SUBJECT:	Review/Action and Public Hearing on the Preliminary Plan for the Cedar Townhomes Plat E Phase 5 located in the H-1 Hillside Development Zone
APPLICANT PRESENTATION:	
STAFF PRESENTATION:	Chandler Goodwin, City Manager

Subject: Geologic Hazards and Geotechnical Engineering Study
Cedar Hills Townhome Development
Sage Vista Lane and North Morgan Drive
Cedar Hills, Utah
CMT Project No. 104124

RE: Memorandum
Response to Geotechnical Review No. 1
Geologic Hazards and Geotechnical Engineering Study
Cedar Hills Townhome Development
Sage Vista Lane and North Morgan Drive
Cedar Hills, Utah
CMT Project No. 104124

Figure:
9

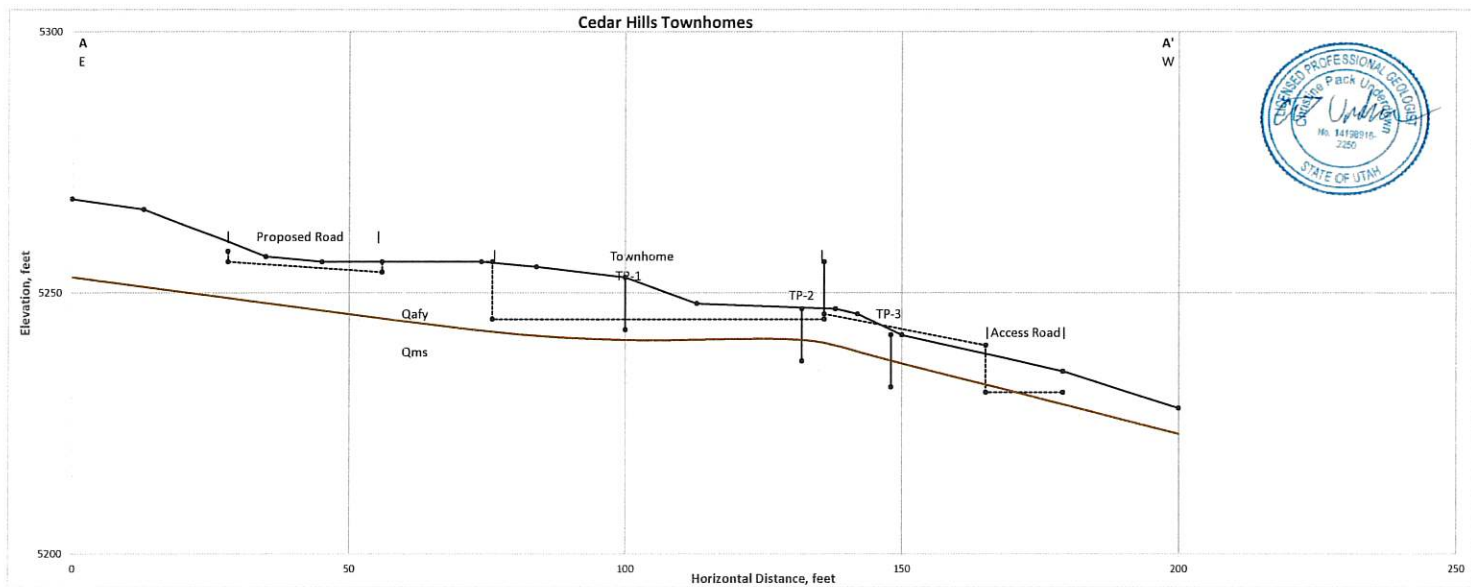
BC&A Comment 13: The proposed development appears that it will make a cut into the toe of the slope on the north side of the development as shown on Figure 9 of the geotechnical report. It appears that relatively minor road cut will not be an issue; however, does the geotechnical engineer believe there is a risk to undermine/adversely impact those existing homes to the north with the road cuts proposed by the development?

BC&A Comment 14: The section views provided by Civil Solutions Group don't seem to show much cut proposed into the existing ground. Conversely, the geotechnical report section view on Figure 9 appears to show cut depths of up to around 10-feet. However, the geotechnical report itself references excavation cuts of 10 to 15-feet expected. Yet the test pits were only dug to 8 to 10-feet of depth. It appears there is some ambiguity on the actual proposed soil cut depths. We'd like confirmation that the test pits were deep enough to provide at least 5-feet of soil depth below the proposed excavation bottoms.

BC&A Comment 15: Figure 9 appears to show the test pit depths relative to the ground surface. Verify that those depths are shown accurately. It appears all of them are shown at approximately 10-feet deep. Yet some might be only 7 to 8-feet deep.

CMT Response: Based upon the concept plan provided to CMT, as the reviewer noted, it appears that the road cut between the existing and proposed residence will be very minor and we do not believe there will be any adverse impact to the existing residences from this road cut. Similarly, we do not believe there will be any impact to the existing residences from the proposed gravel road cut on the south side of the development.

CMT Response: There is a discrepancy between the cuts indicated on Figure 9 of the geotechnical report and the concept plan provided by the civil engineer which showed maximum cuts of about 5 feet. It is CMT's opinion

that the civil drawing is the more accurate representation of the proposed site grading and as such the test pits did extend to sufficient depth to provide at least 5-feet of soil depth below the proposed excavation bottoms.

CMT Response: The discrepancy is most likely related to the use of publicly available topographic data to develop Figure 9, while the site cross sections prepared by the civil engineer likely used survey topo data.

CMT TECHNICAL SERVICES	Project		Cedar Hills Townhome Development	
	Analysis Description		Global Slope Stability	
	Drawn By		J. Egbert	Company CMT Technical Services
	Date		1/29/2026, 2:27:26 PM	File Name Cedar Hills Townhomes Slope Stability - Copy.slmd

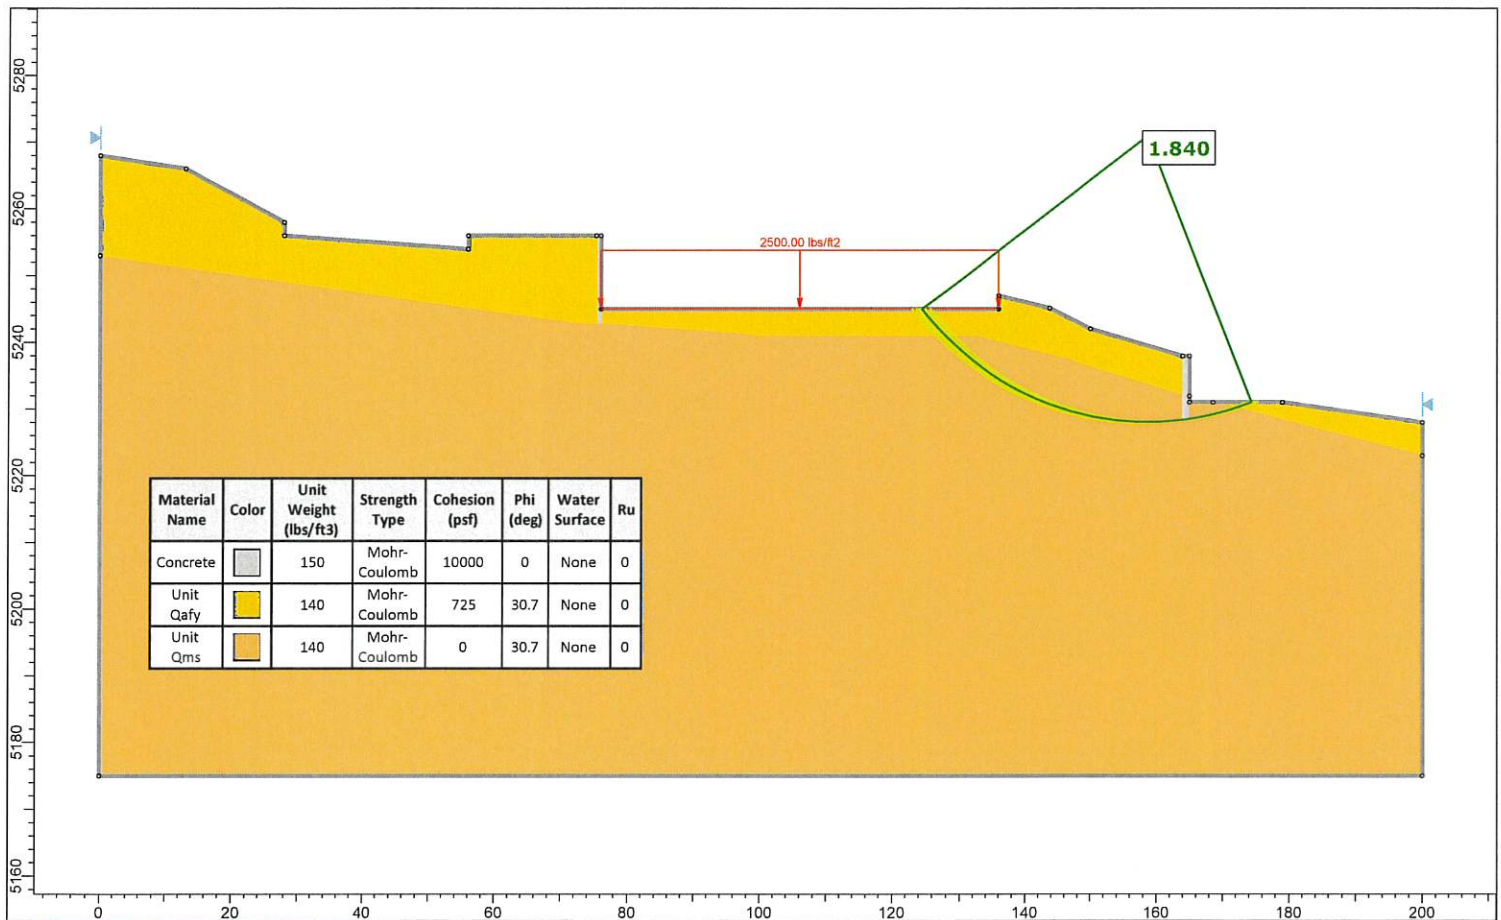
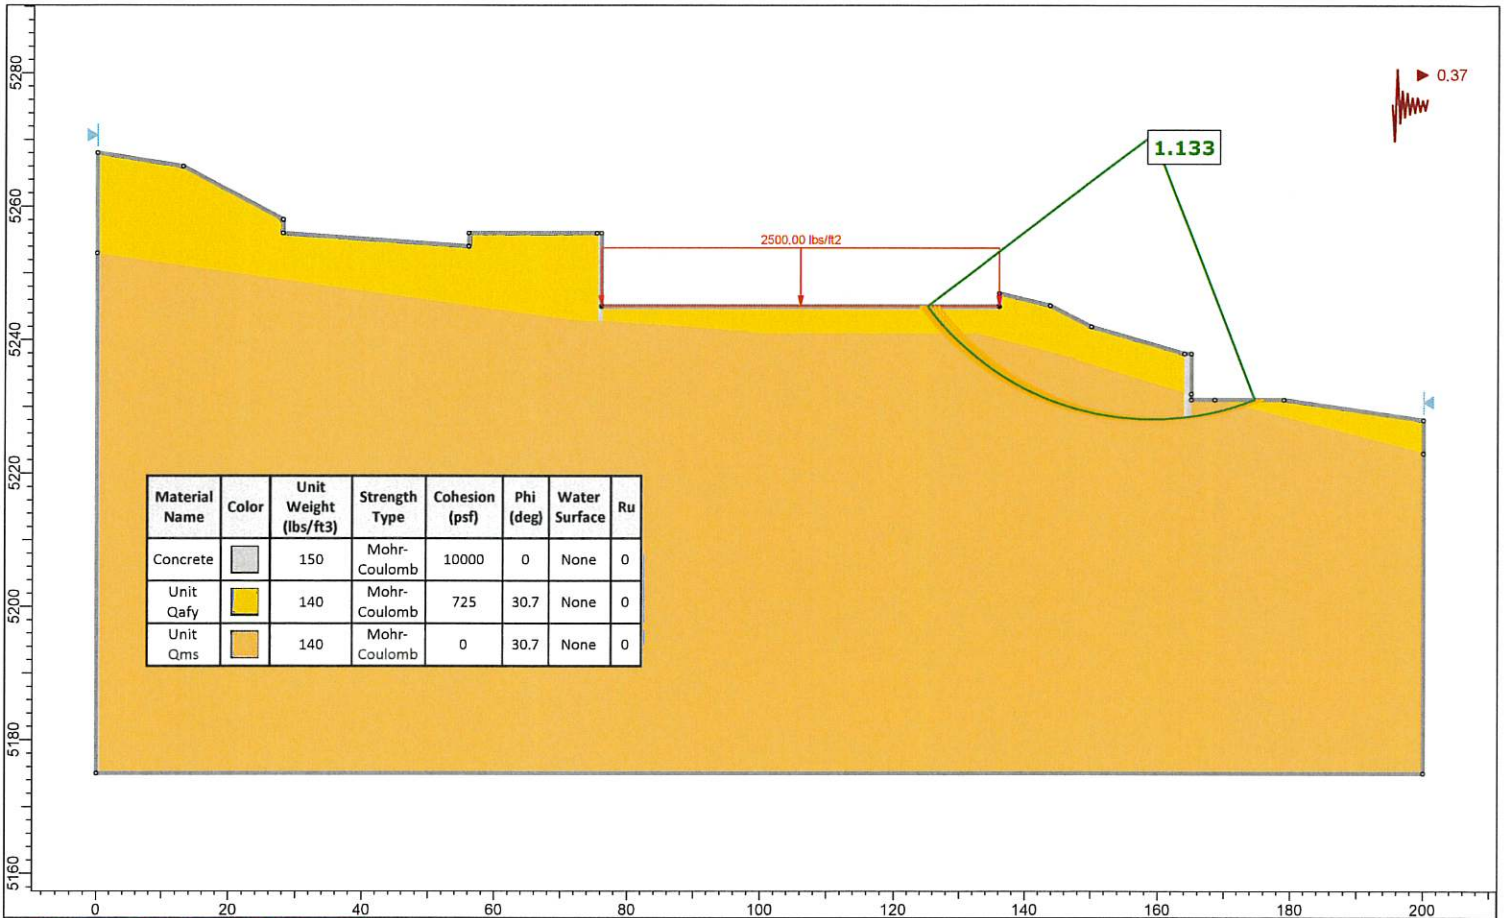
BC&A Comment 18: The slope stability scenario with a factor of safety of 1.133 shown on the figure doesn't appear to have supporting calculations provided.

CMT Response: The Input-Output data for the seismic analysis has been added to the revised report.
